Inquiry into Territory Plan Draft Variation 364

on behalf of LandCo Pty Ltd

Thank you for the opportunity to provide commentary in relation to the Inquiry into Territory Plan Draft Variation 364 (DV364) for proposed variations to the Gungahlin Precinct Code. This submission is made on behalf of the Lessee for Block 6 Section 88 Gungahlin, Landco Pty Ltd.

Figure 16 Maximum numbers of storeys in Precinct 2b

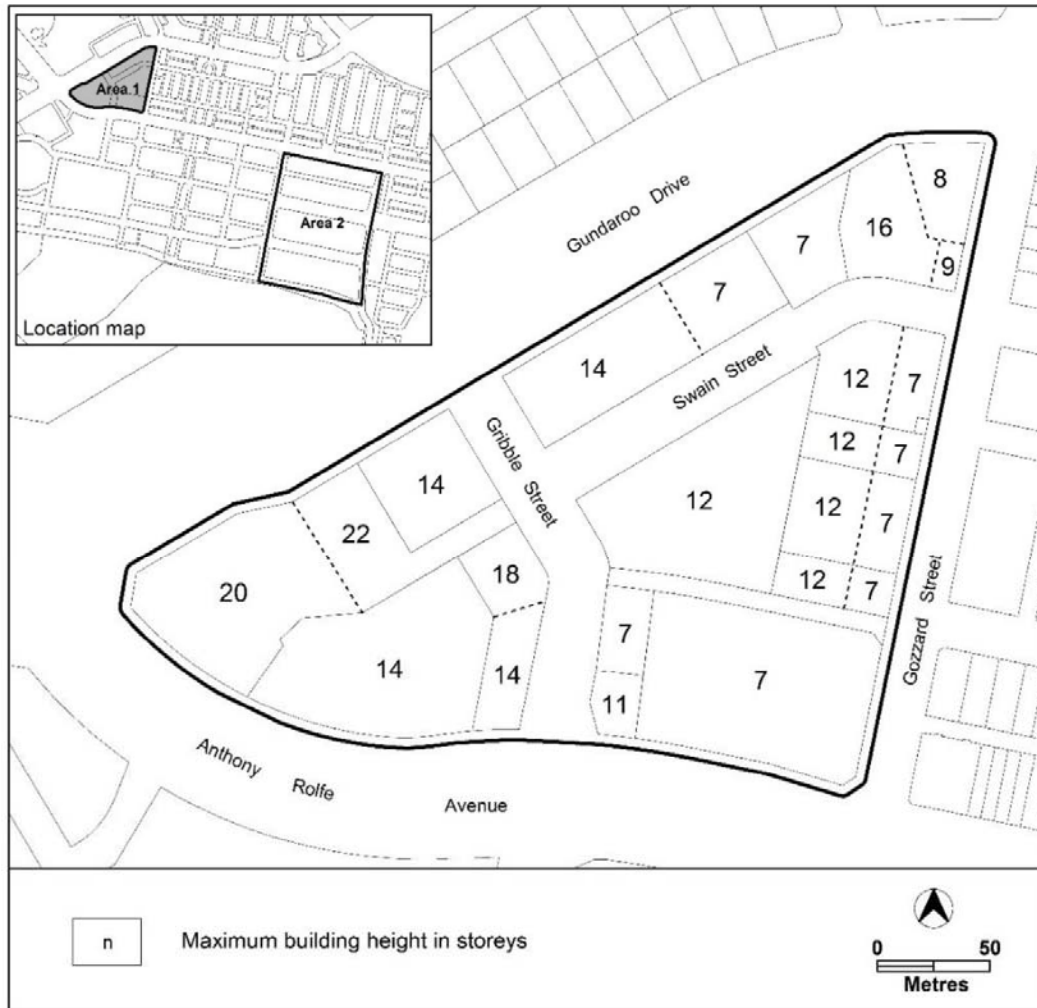
The changes proposed to building heights permitted within Precinct 2b (Figure 16 of the Precinct Code) impact the development opportunity on Block 6 compared to the opportunity previously available under the Precinct Code, and are considered incompatible with the character and form of surrounding development in this Precinct.

Where previously Block 6 had no defined height limit (following the lifting of the building height sunset clause under the Precinct Code in November 2015), a 12 storey height limit now applies. Earlier developments within the Precinct have benefited from the absence of a building height control where remaining sites will now be required to comply with specified heights.

The height limit applied to Block 6 is inconsistent with surrounding development of 14, 16, 18, 20 and 22 storeys and inconsistent with good planning and urban design practices for the siting of tall buildings, where the pattern of development typically includes the tallest buildings towards the centre of a high density precinct, tapering down to shorter buildings towards the edges of a precinct adjoining lower scale development.

Figure 16 indicates proposed building heights in Precinct 2b, which specifies building heights of at least 7 storeys with up to 22 storey elements at focal points. A greater scale of development is permitted on the Mixed Use North East sites, whereas the Mixed Use North West precinct is intended to be intensely developed, yet includes larger setbacks than for the Mixed Use North East Precinct.
